Access Compliance Report

Public Rights-of-Way

(Curb Ramps)

Intersection ID: 29768	Main Street: KNIGHT_CASTLE_DR	Cross Street: WILD_AZALEA_LN	Location: SW
ADA ID: 3BE2BF18BEA9	Ramp Type: PerpDiag	Initial Pass/Fail: Fail	Overall Compliance: No
Severity Score: 67.5			
Codes/Mitigation Info/Possible Solution		Field Measurements/Component Compliance

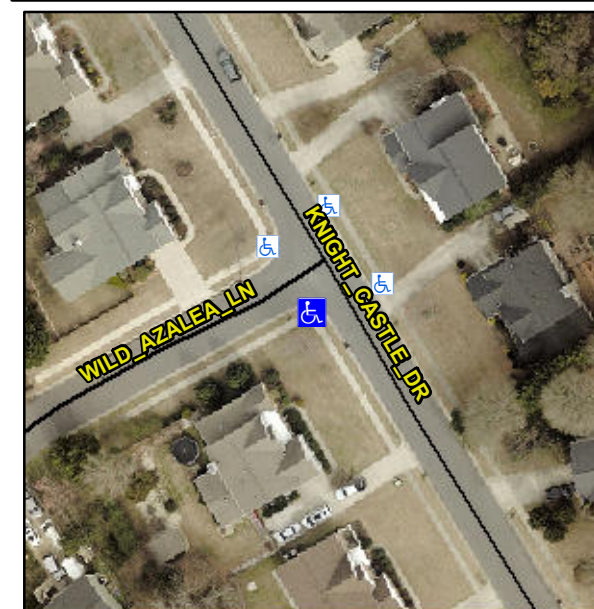
Not Found, R304.5.1, R304.2.2, R304.5.3

Compliance	Description	Data	Compliance	Description	Data
N/A	Ramp Length (in)	96.0	No	Ramp Slope (%)	12.4
No	Ramp Width (in)	35.0	No	Ramp XSlope (%)	9.3
N/A	Flare Type LT	N/A	N/A	Flare Type RT	N/A
N/A	Flare Slope LT (%)	N/A	N/A	Flare Slope RT (%)	N/A
N/A	Flare Traversable LT?	N/A	N/A	Flare Traversable RT?	N/A
N/A	Landing Length (in)	N/A	N/A	DWS Provided?	N/A
N/A	Landing Width (in)	N/A	N/A	DWS Contrast?	N/A
N/A	Landing Slope (%)	N/A	N/A	DWS Length (in)	N/A
N/A	Landing X Slope (%)	N/A	N/A	DWS Full Width?	N/A
N/A	Landing Curb? (Y/N)	N/A	N/A	DWS Offset (in)	N/A
N/A	Shared Landing?	N/A			
N/A	Gutter Ponding?	N/A	N/A	Gutter Slope (%)	N/A
N/A	Gutter Lip Ht (in)	N/A	N/A	Gutter X Slope (%)	N/A
N/A	Painted X Walk1?	No	N/A	Painted X Walk2?	No
	X Walk 1 Direction	To NE		X Walk 2 Direction	To E
N/A	X Walk 1 Width (in)	N/A	N/A	X Walk 2 Width (in)	N/A
	X Walk 1 Slope (%)	3.5		X Walk 2 Slope (%)	3.4
	X Walk 1 X Slope (%)	0.7		X Walk 2 X Slope (%)	0.5

Remove & Replace Curb Ramp With Two New Directional Ramps or Equivalent.
